E1200535-v17

TMS WORK TO DO LIST GOING FORWARD

7-20-2012

PICTURES OF THE UK AT CALTECH, AND OUR DRAWING NOTE THE GUSSET

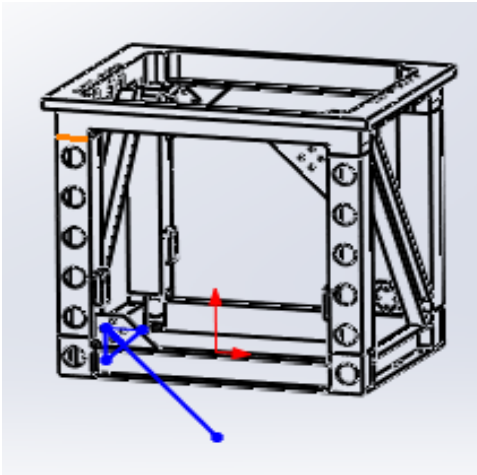
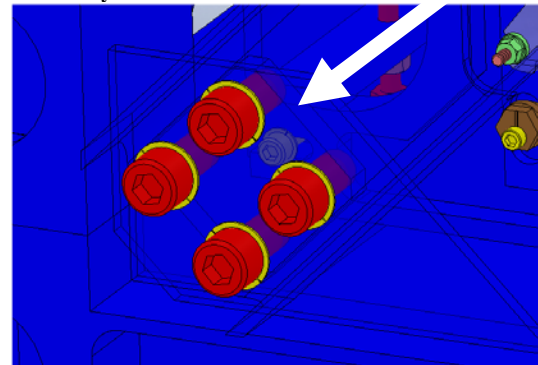
2. D060492 QUAD WELDED FRAME NEEDS TO BE UPDATED IN THE TMS DRAWING AND ASSEMBLIES TO SHOW THE 'UK' STYLE CONSTRUCTION.

THIS CORNER ATTACHMENT FOR THE CHANNEL STIFFENER WELDED IN BRACKET ATTACH POINT (4 PL) RATHER THAN THE NOW SHOWN GUSSET JUST WELDED IN THE CORNER ON THE SURFACE OF THE TUBE.

ALSO TO CHECK THE DRAWING FOR THE CHANNEL STIFFENER THAT THE PORT HOLE IS SHOWN FOR THE CONNECTOR CLEARANCE FOR THE BREADBOARD REF. 'UK' PART TD-1084-436

ALSO A NEW TOOL FOR ACCESS TO THE BREAD BOARD CAP SCREW OR THE SCREW IS CHANGED TO A HEX HEAD TO EASE ACCESS.

ACCESS TO THIS SCREW (SEE NOTE ABOVE) NOT needed anymore

PART NAME: D060499
 D060492

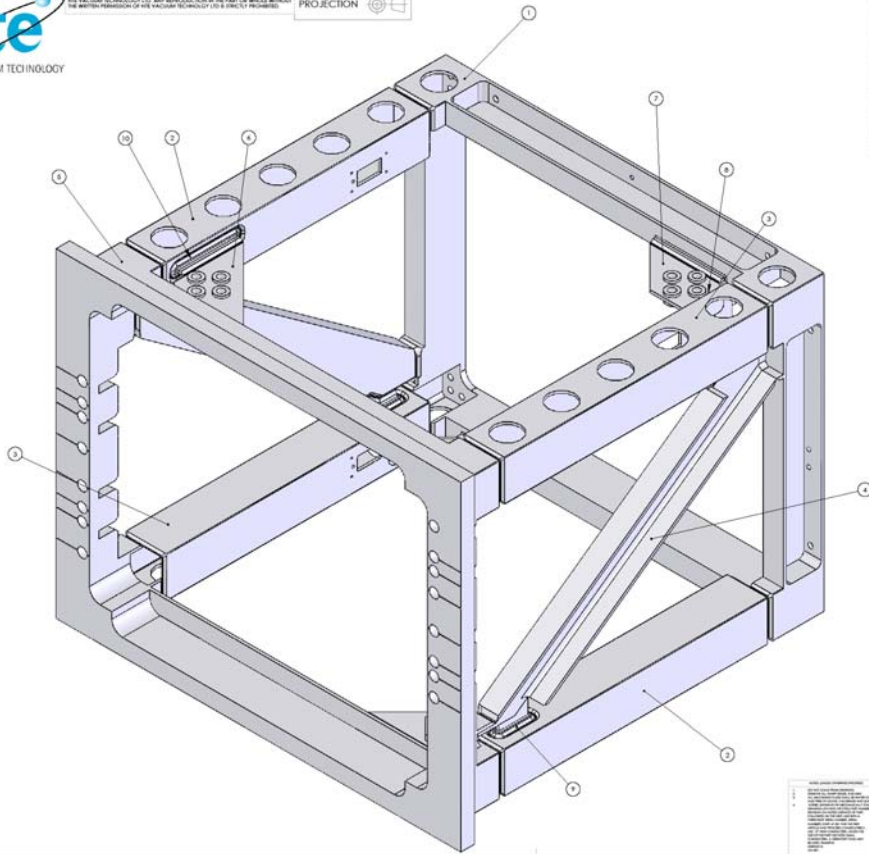
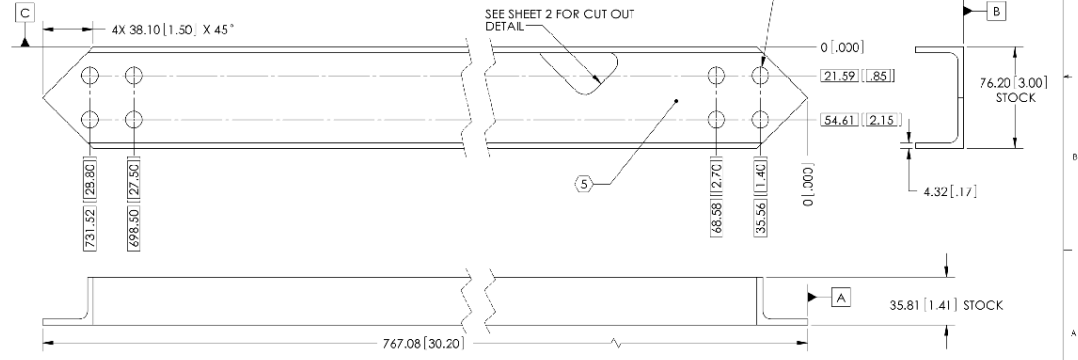
REF BELOW FOR STIFFENER AND ATTACHMENT GUSSET INFORMATION

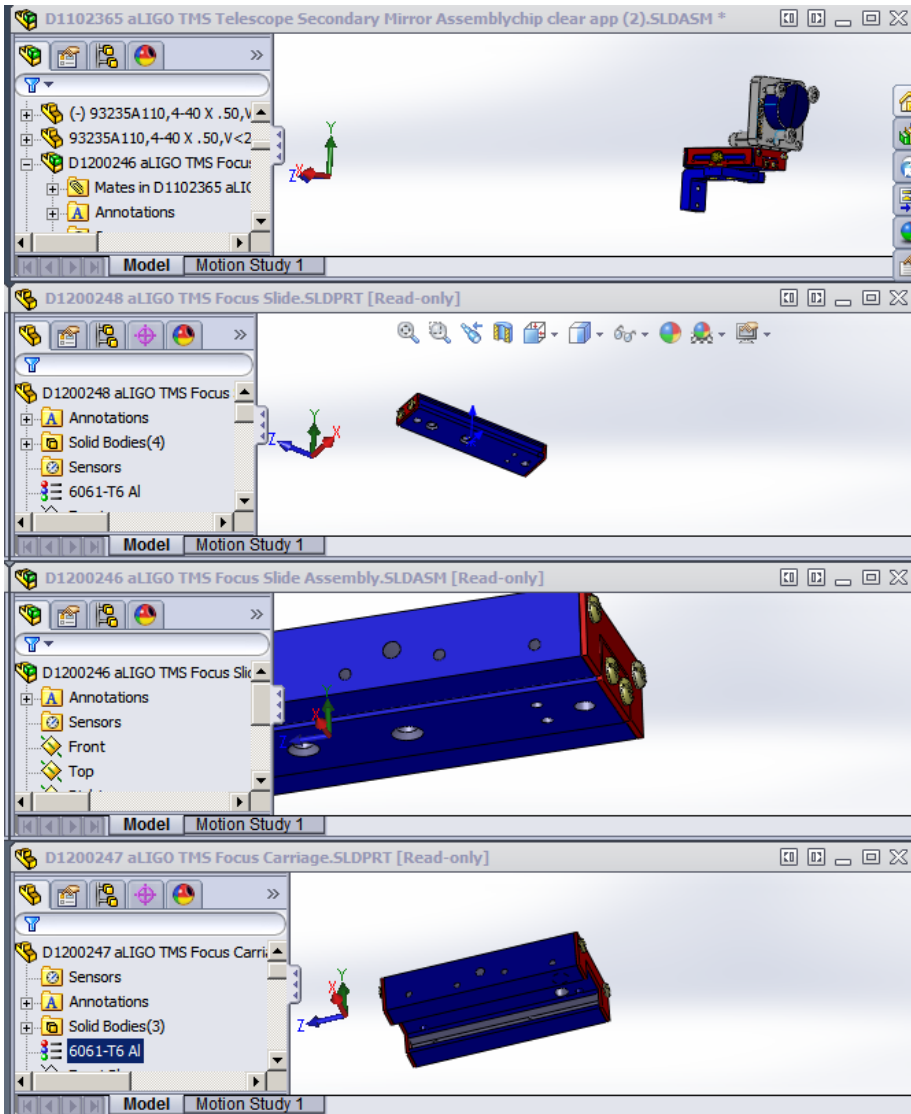
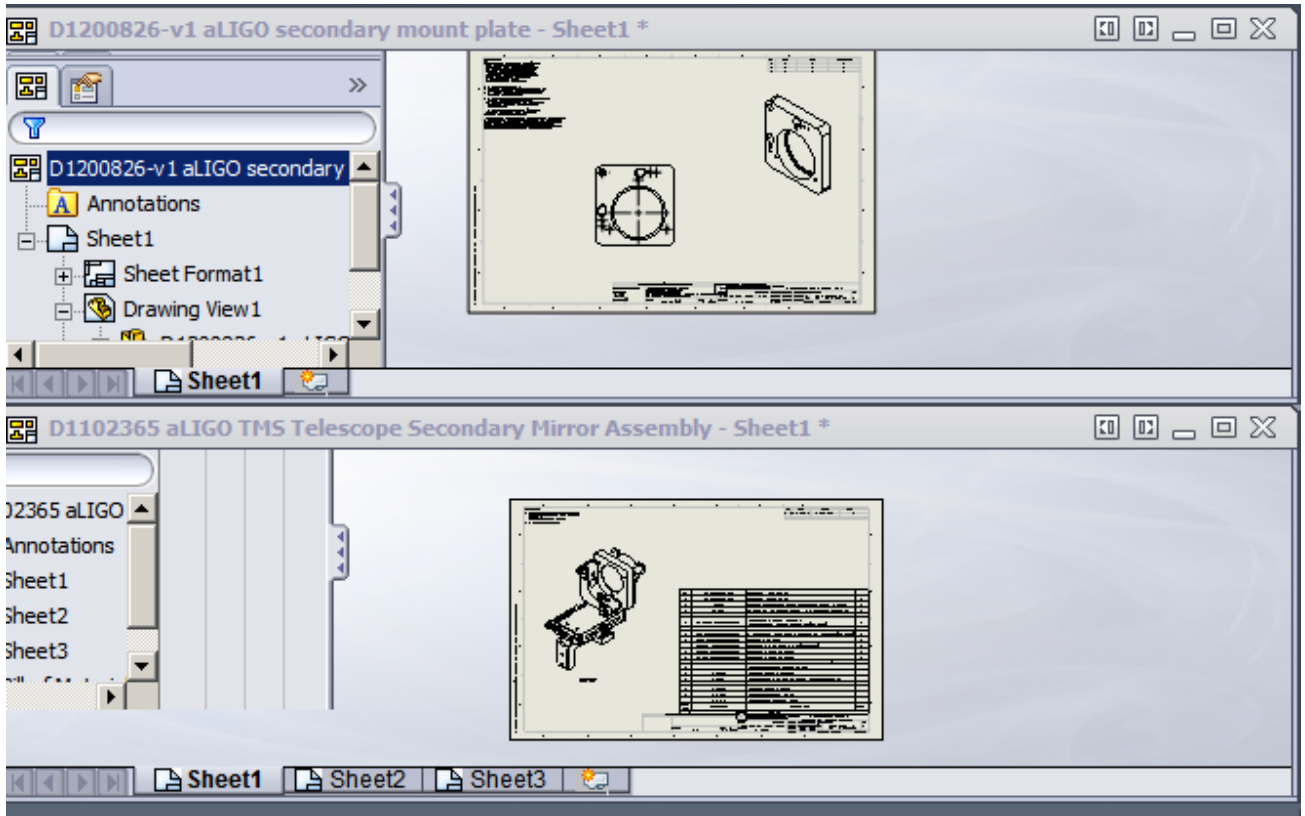
All - Should these parts to be cleaned to class B or wiped down prior to leaving CIT?

Calum,
after a good initial cleaning to get the mfg. dirt off,
last time we wiped it, with alcohol, while it was attached to the door, before we
attached it to the flanges.

this assembly is really outside, even more than the arm, it never touches anything in vacuum.
except for the tubes, everything is small, can be put in the sonic bath.
